**Asheboro Planning Board
Asheboro City Hall (146 N. Church Street)
Monday, December 4, 2023
7:00 PM
AGENDA**

RZ-23-14: Request to rezone property located along the west side of Zoo Parkway and the south side of Newbern Avenue from R40 Low-Density Residential, R15 Low-Density Single-Family Residential, and R10 Medium-Density Residential to R7.5 (CZ) Medium-Density Residential Conditional Zoning for a Residential Planned Unit Development

Attachment 2: RZ-23-14 Hillcrest Farms: Proposed conditions as of November 30, 2023
(Subject to change following comprehensive review of latest plan submitted)

CONCEPTUAL REZONING PLAN
HILLCREST FARM SUBDIVISION
RANDOLPH COUNTY, ASHEBORO, NC
AUG. 2023

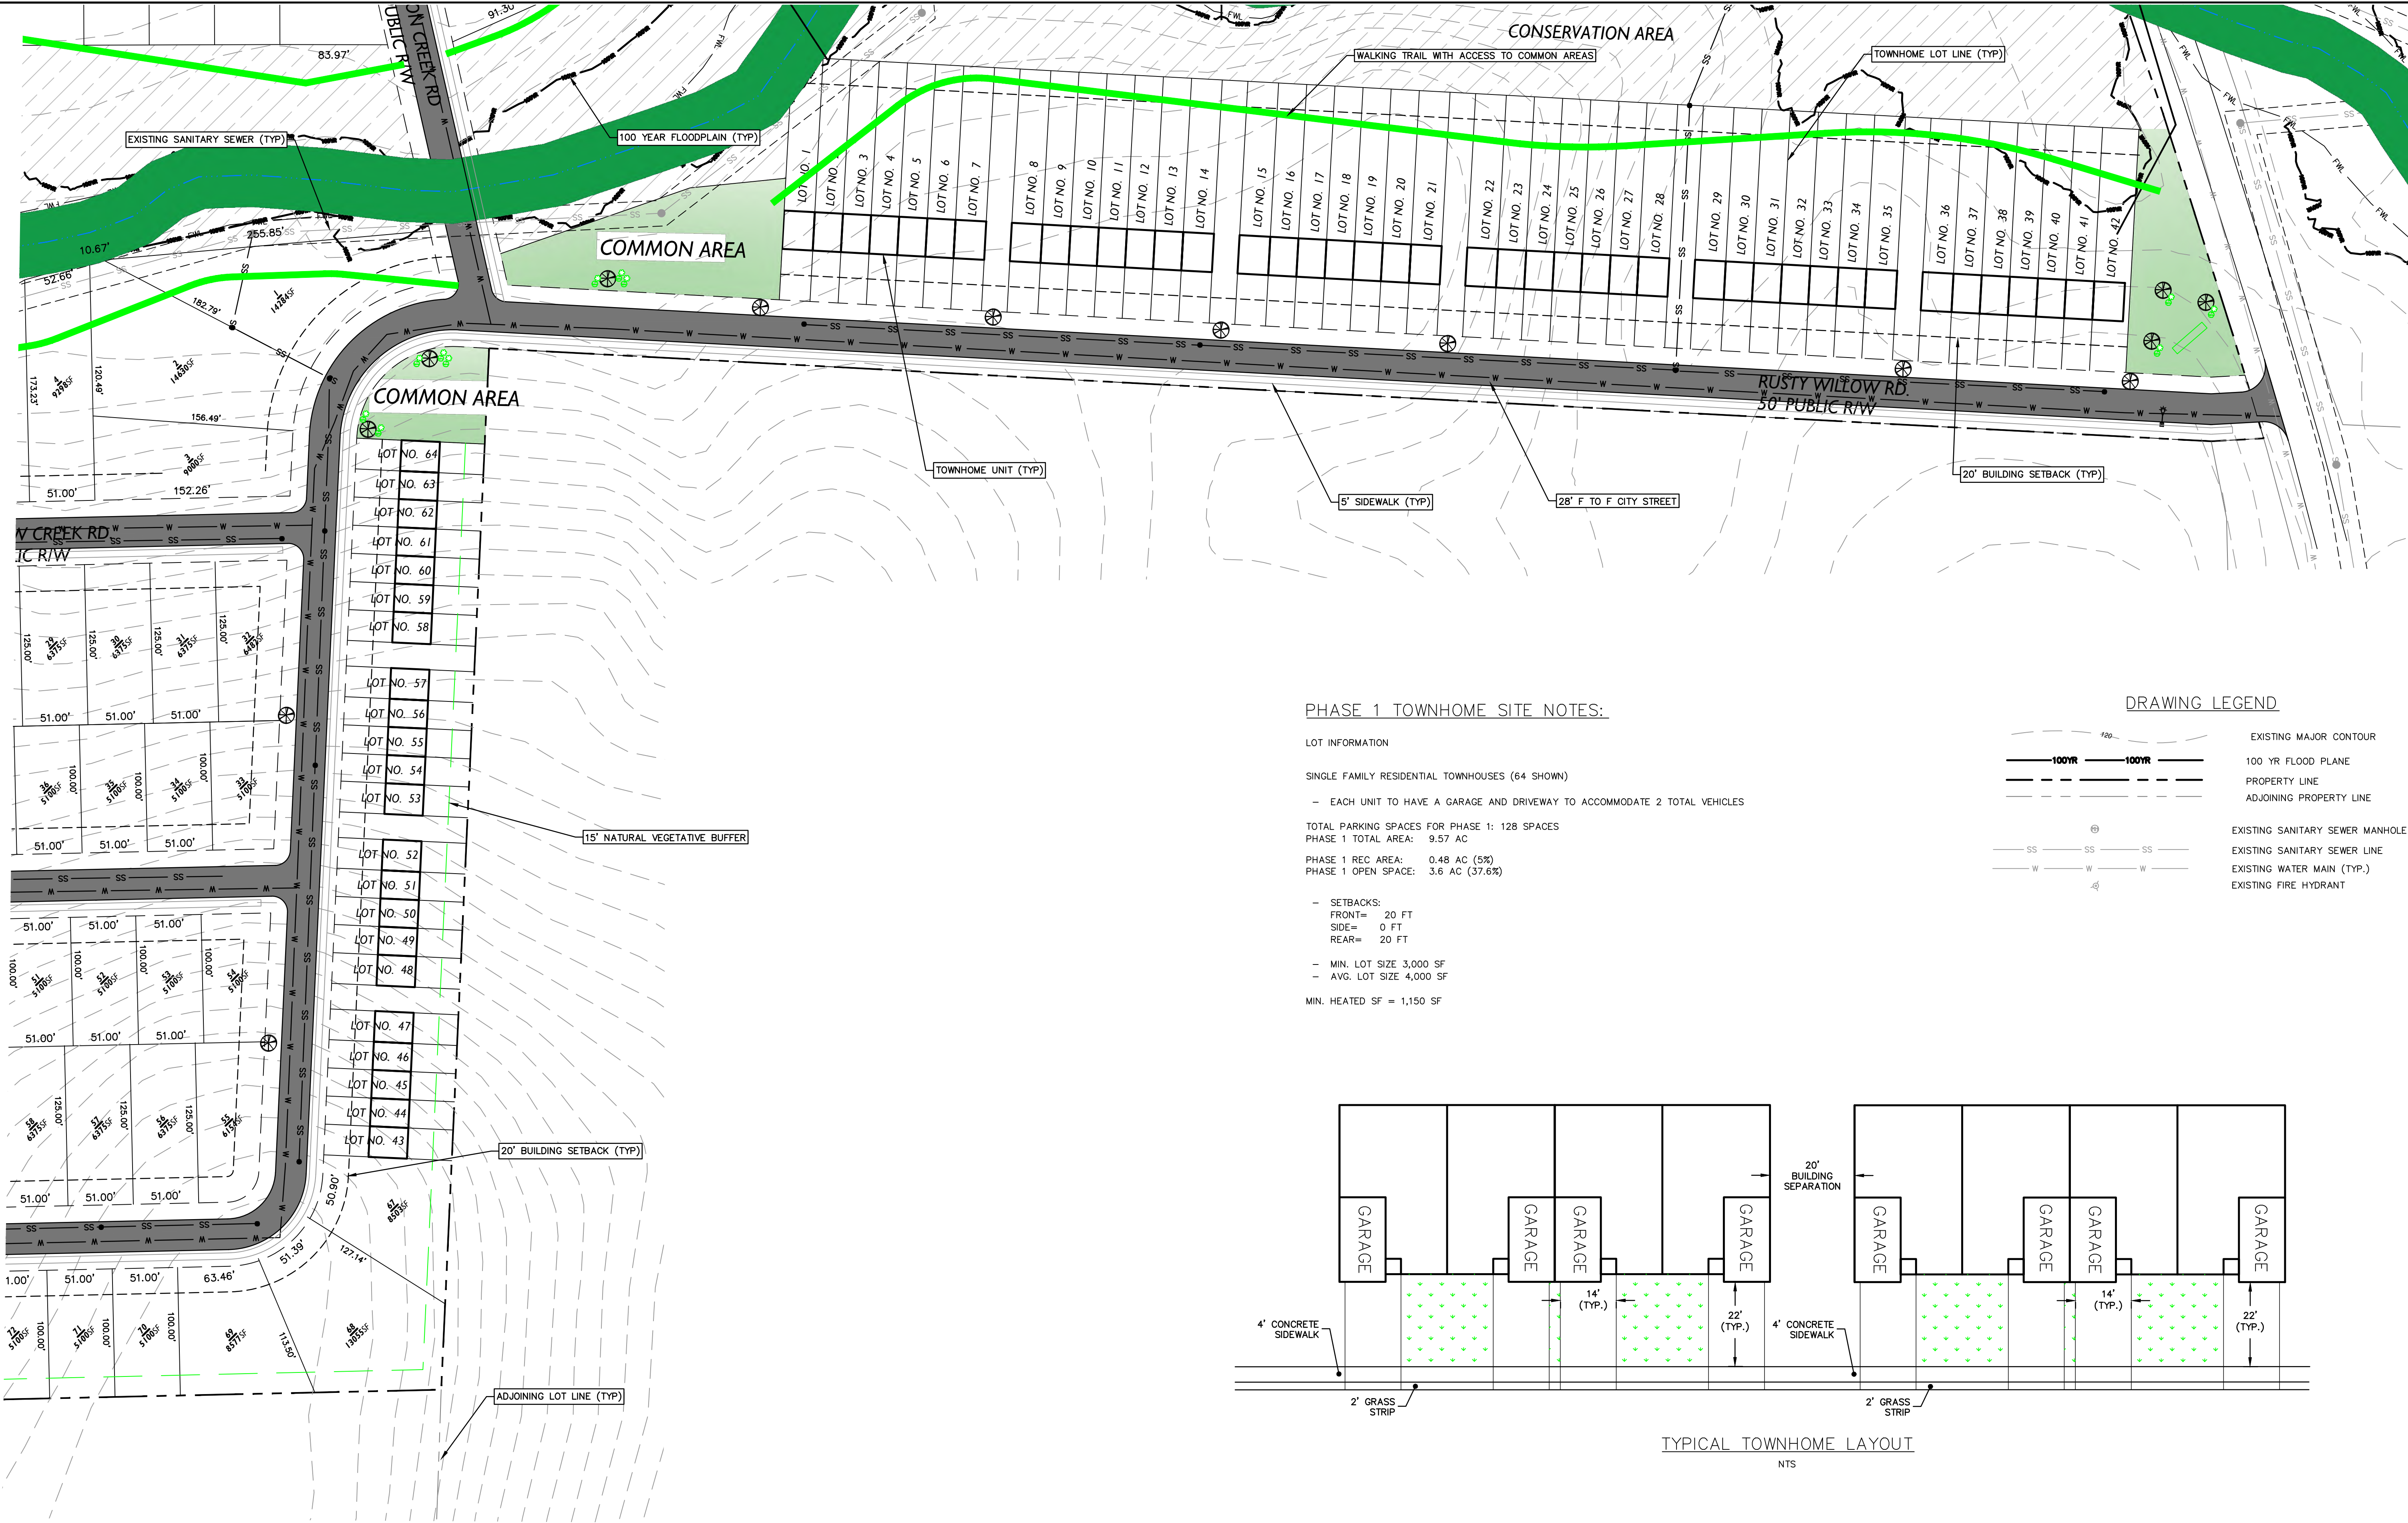
2. The request is for a residential Planned Unit Development. The latest plan, received on November 28, 2023, shows a total of 349 dwellings on 349 lots, an increase in 3 dwellings from what was shown on the previous draft of the plan. 285 of these units are detached single-family residences. 64 units are attached townhome style dwellings, clustered in groups of 5 to 7 attached dwellings.

6. Staff had suggested additional fencing be provided adjacent to two additional residential properties (Parcel Identification Numbers 7760013216 and 7760014240) along Newbern Avenue. In lieu of that fencing, the applicant revised the site plan to add common elements on both sides of the street entering the development from Newbern Avenue (Orchid View Drive). This revision increases separation between new lots and existing homes.

7. Sidewalks customarily are required for a Residential Planned Unit Development and typically is expected to connect all lots and amenities to existing streets. The site plan proposes a sidewalk network only on one side of the new streets which is not adequate under the code when lots are proposed to be on both sides. Staff has identified this deviation and, in response, the applicant has added a trail that would provide additional pedestrian access for many of the lots. The latest plan makes additional adjustments to the trail’s location to improve the access of this trail to lots within the development. Several lots, however, remain unconnected to a pedestrian feature (Lots 2, Lots 11-16 and Lots 103-132), and the common area south of the intersection of Wagon Creek Road and Rusty Willow Road.

14. Staff continues to review the latest site plan and will provide an updated report should the case be continued.

- (H) Prior to the recording of Memorandum of Land Use Restrictions outlined in (CC), the site plan shall be revised with the following information and resubmitted to the Planning Department for review of code compliance and inclusion in the file without further review by the Council:

- (i) Labeling of recreation area on plan sheets.
 - (ii) Labeling of adjacent property zoning within 50' of subject property.
 - (iii) Labeling of all lot dimensions.

- (v) Clarification on site plan that stormwater management is the responsibility of the property owner and/or homeowners' association outside of the public right-of-way.
